Citylabs 4.0

Condition 10 Drainage Scheme

Appendix A - 30/05/25 in response to LLFA Comments 07/03/2025

LLFA Comments 07/03/2025

Drawing Title
**External Works
Drainage
General Arrangement**

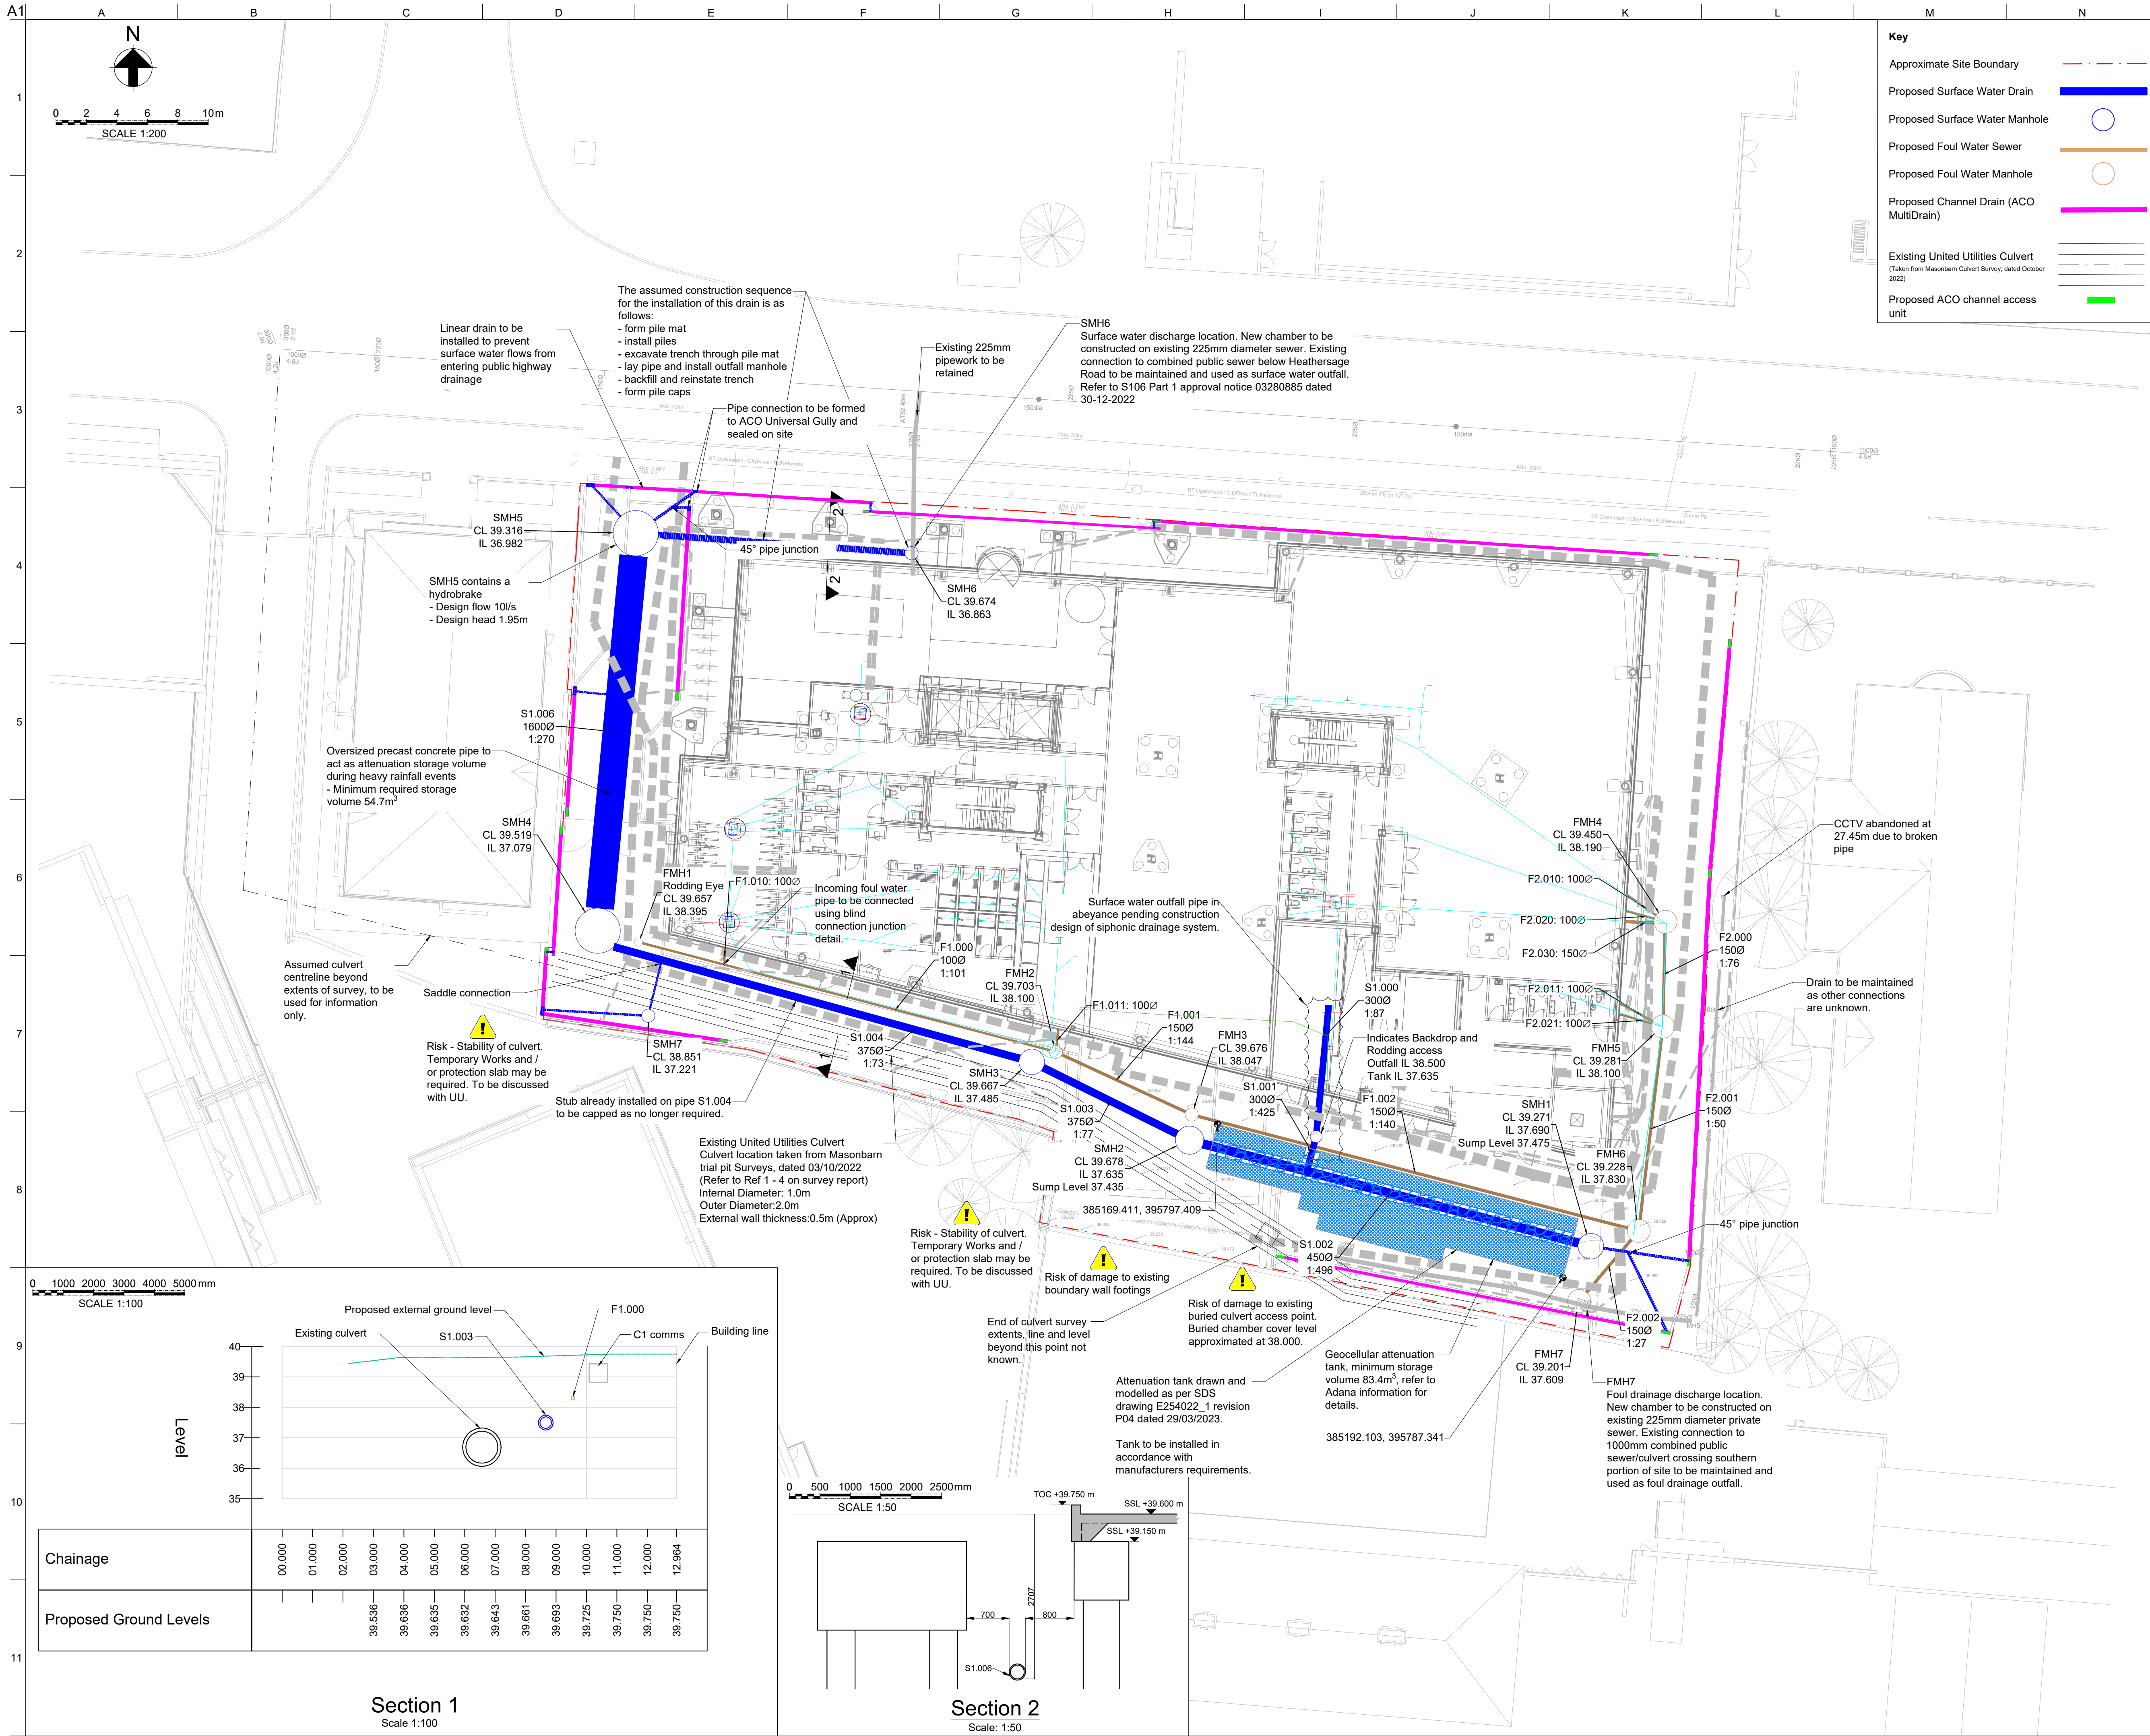
Decision Notice Clause	Contained in submission	Approvable standard	Further information required:
Prior to the first occupation of the development details of the implementation, maintenance and management of the drainage scheme for each phase shall be submitted to and approved in writing by the City Council as local planning authority. The scheme shall be implemented and thereafter managed and maintained in accordance with the approved details. Those details shall include: - A verification report providing photographic evidence of construction as per design drawings.	N	N	Please update with the photographic evidence of flow control and storage tank.
As built construction drawings (if different from design construction drawings).	Y	N	Please update with the evidence for storage Volume of Attenuation tank, flow rate , connection point to the outfall showing how it connects to the public sewer.
A management and maintenance plan for the lifetime of the development which shall include the arrangements for inspections, adoption by any public body or statutory undertaker, or any other arrangements to secure the operation of the sustainable drainage scheme throughout its lifetime.	Y	Y

% Complete submission:	66 %
% At approvable standard:	33 %
Refusal trigger points: Submission 1 = less than 20% complete. Submission 2 = not 100% approvable standard.

LLFA Recommendation:	Further information required (as detailed above).
-----------------------------	---

Just seen your call, please see the two drawings attached and below for the narrative regarding the provided storage volume. If there's anything else you need let me know.

As agreed during consultation with the Lead Local Flood Authority, surface water is discharged via the existing on-site connection to the public combined sewer within Hathersage Road via a flow control device with a 10l/s flow restriction and a design head of 1.95m, installed within chamber SMH5 in the north west corner of the site. Attenuation of surface water within the site has been designed to provide at least 140m³ of storage, through a combination of an oversized pipe, providing a 54.7m³ storage volume, supplemented with a geocellular storage tank providing 83.4m³ with the remaining storage volume provided within the wider below ground surface water drainage system. Inspection of the hydraulic modelling results for the 1 in 100yr +40yr cc storm event demonstrates that no surface water flooding occurs during this event.
